RE: Safety Recall 14E-034

Subject: Volume Mount Bracket Safety Recall Notice #14E-034

Important Safety Recall

NHTSA Recall Number: 14E-034

Figure 1. Fluid Volume Mount Brackets

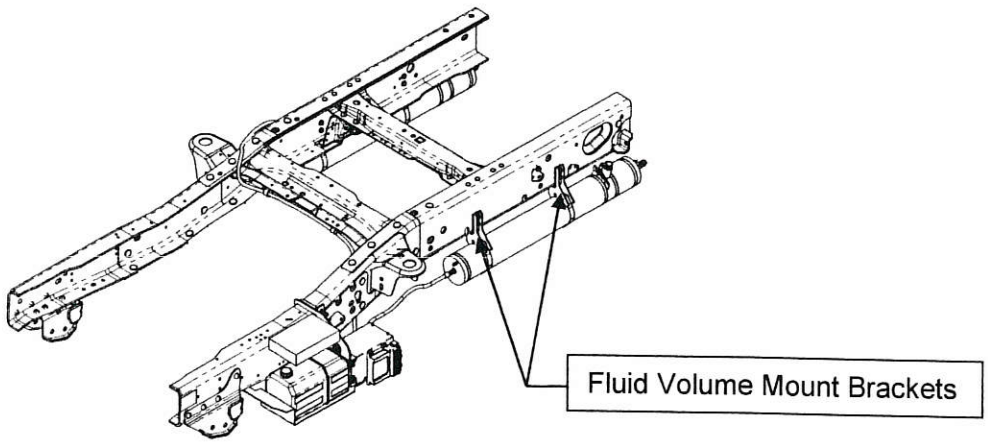
LiquidSpring LLC has decided that a defect which relates to motor vehicle safety exists in a component in certain LS suspension systems installed on Ford E450, F450, F550, and GM G3500/4500 chassis, and only suspension systems for the above chassis are included in the safety recall.

These suspension systems are typically installed on ambulances, shuttle buses, RV's, and other specialty vehicles. The affected system component is the fluid volume mount bracket. The bracket may develop a fracture that may result in the fluid volume becoming supported only by hose connection(s). Continued vehicle use in this fluid volume support condition [hose connection(s) only] may result in the fluid volume contacting the ground which could cause damage to the chassis and/or other vehicles, and possibly result in a crash. See Figure 1 for location of fluid volume mount brackets on the chassis.

Existing Brackets	 10830-002	 10830-003	 10830-010*
Replacement Bracket	 10830-013

*If suspension system is equipped with 10830-010 volume mount brakes and dual band clamps, please contact LiquidSpring for replacement band clamp.
